October 15, 2021

Municipality of Clarington
40 Temperance Street
Bowmanville, Ontario
L1C 3A6

RE: Review of Arborist's Reports for 21 Beech Street, Bowmanville, Ontario

Tomogram of Cross-section Shown in Above Photograph

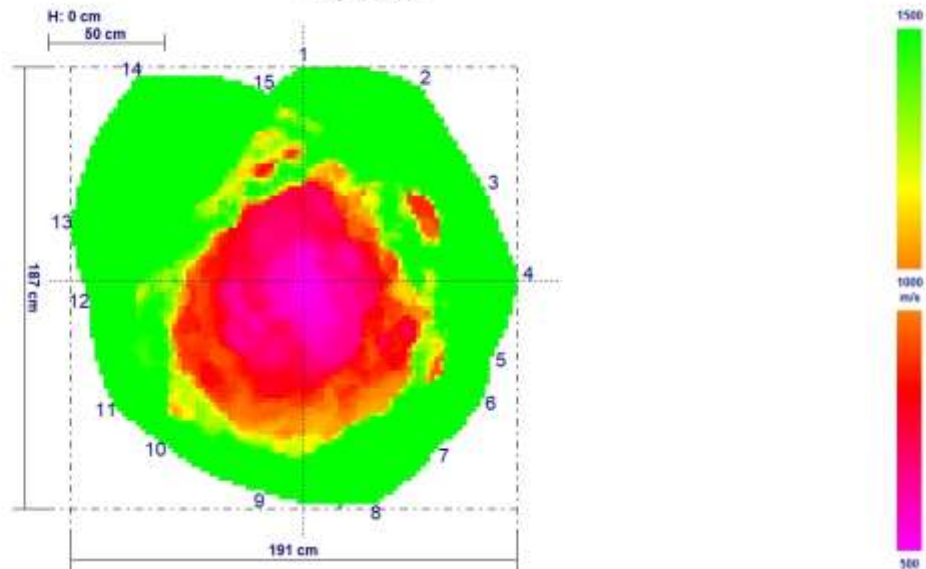
1. From Michael Richardson: The Tomogram Cross-section on page 10 shows an intact wall of live, solid wood and the Resistograph Drilling confirmed the same. This was done one metre above the ground but from my observations, I believe that this characterizes the entire trunk, up into the crown. Therefore, the structural stability of the trunk is not in question. Michael also mentions this on page 7 of his report when referring to the large limb that did fail. He said, "The cavity within the trunk played no role in the failure". I would agree with that statement.
2. Both reports indicate the current risk is with the two long, heavy limbs; one on the west side and one on the south side. I would agree. The union of the two limbs with the trunk both have included bark which creates weakness and the possibility of failure.
